**PUBLIC NOTICE
CITY OF BEXLEY
ARCHITECTURAL REVIEW BOARD**

Address: 137 S. Roosevelt

ARB Request: The applicant is seeking architectural review and approval, to allow a new open front porch addition, and modifications to the soffits, windows and doors.

PROJECT DESCRIPTION:
**WHOLE HOUSE REMODEL
137 S. ROOSEVELT AVENUE
BEXLEY, OHIO**

SHEET TITLE:
SITE PLAN

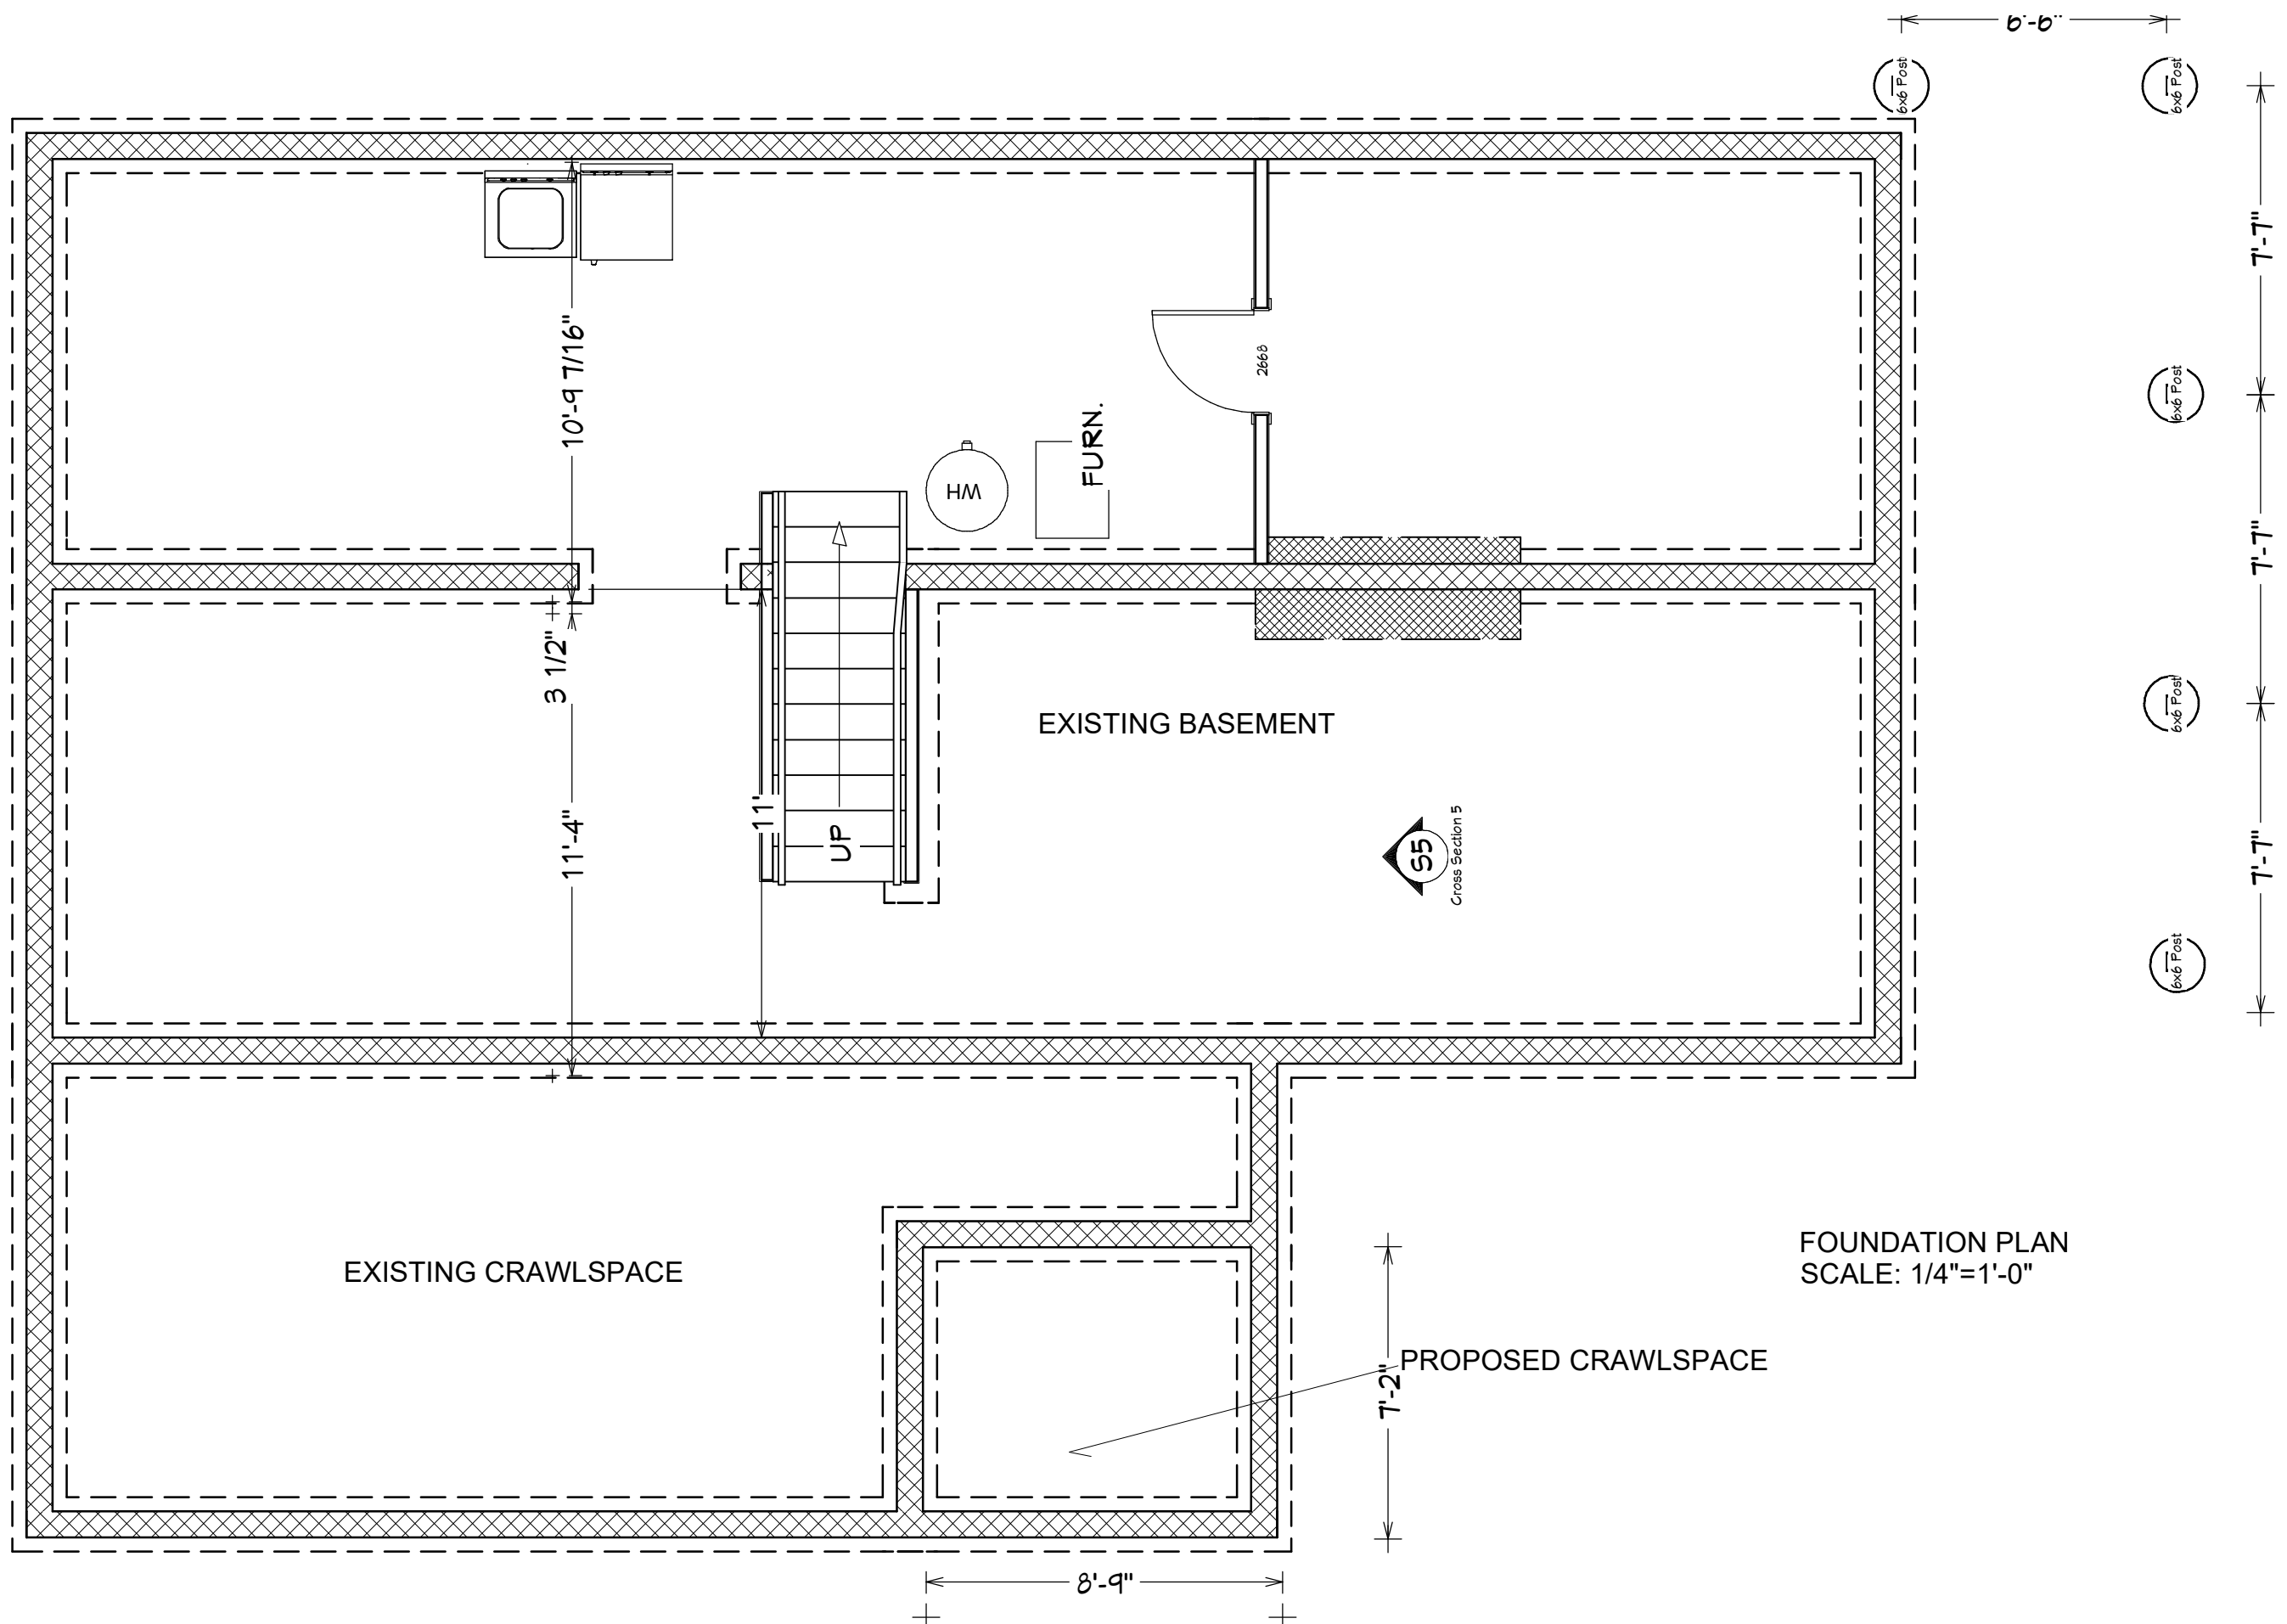
I have the average setback at approximately 40' 6" Can you tell me the depth of the full front porch w the cover?

Still need a survey to determine the distance from the south property line to the porch roof proposed.

Yes, per the plans it looks like the deck is a total of 8.6ft. 7 ft porch with 18" of steps, putting the set back to 32 ft. This is noted on page 1 (set back) and page 3 (measurements) for porch.

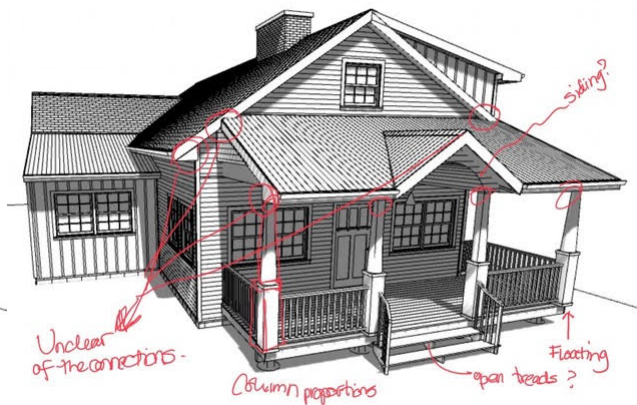
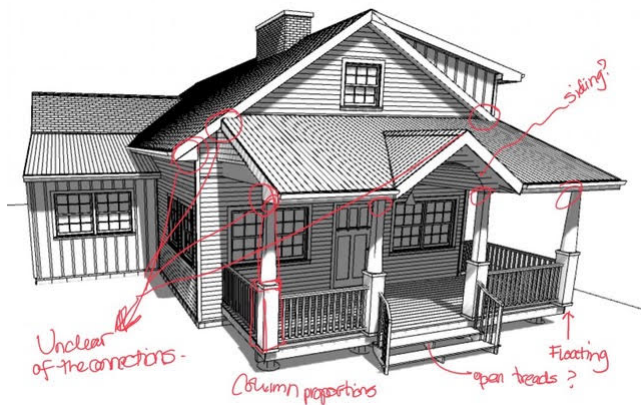
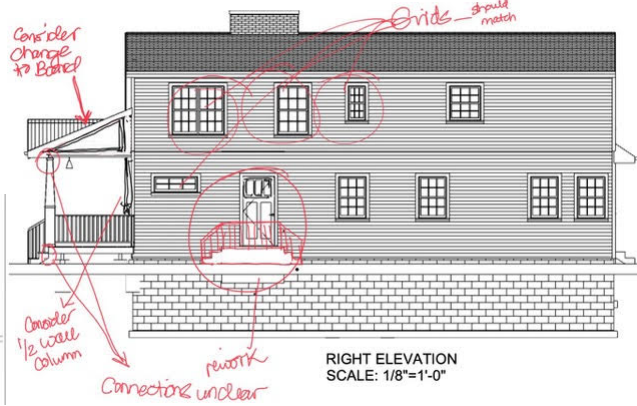
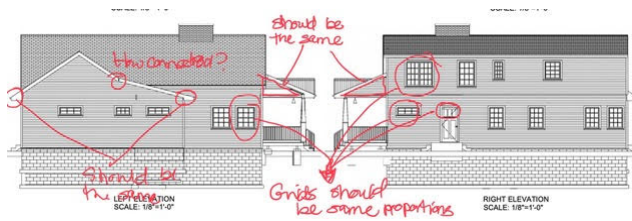
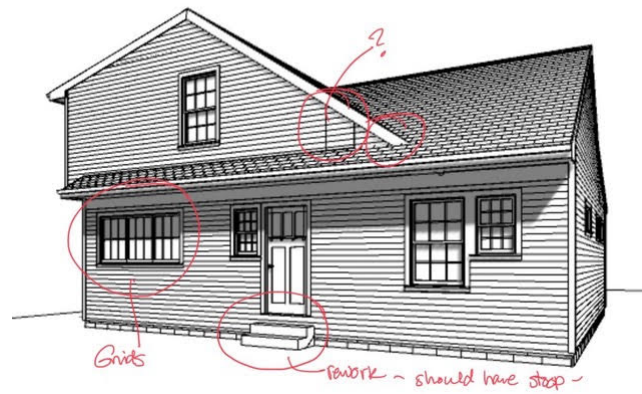
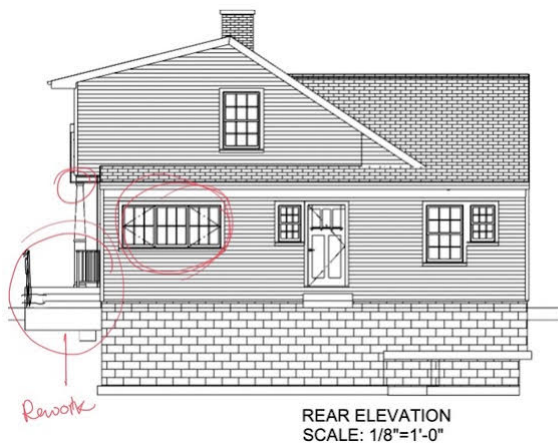
I really don't know what more I can do to help you - I have specifically redlined everything I know will be an issue to the Board. Here are the redlined drawings again.....

Here 2 of the drawings that were submitted on April 30th -

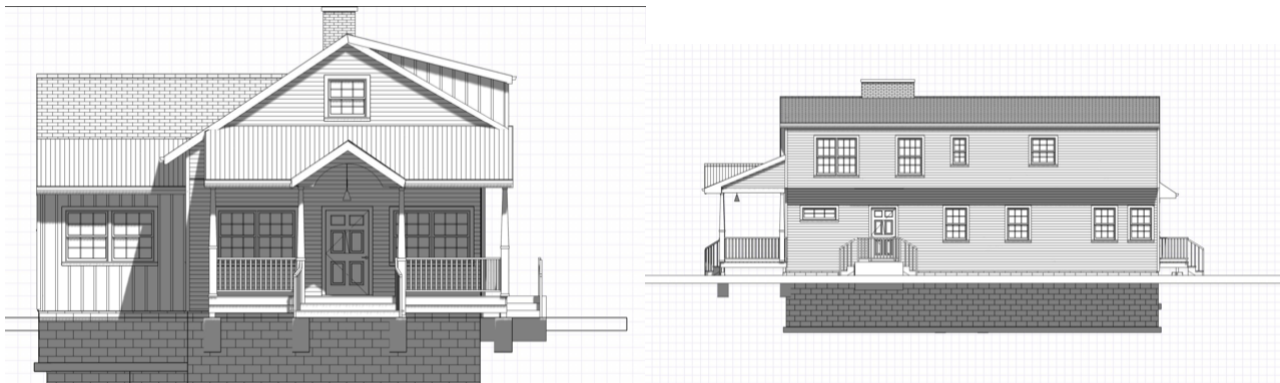
They are definitely better - which is something I have already shared - but there are still a lot of details that are strange and not worked out - the column bases are still floating off the porch, columns are weirdly proportioned, the railing in back don't connect, the steps in the back are disconnected from the new stoop - are they the same unit? wood? concrete? Just so many details that the Board will ask about and I am certain it will get tabled to work on these details. I am allowing this to come to the Board but want to be realistic about what you should expect. I am really at a loss how else to point out all of these details without doing them myself which I cannot. Below is an example of how we need to see details... I believe I sent you some example drawings already too and you can access our past applications to look at other applicants successful drawings on the city's website under documents/agendas and meetings....
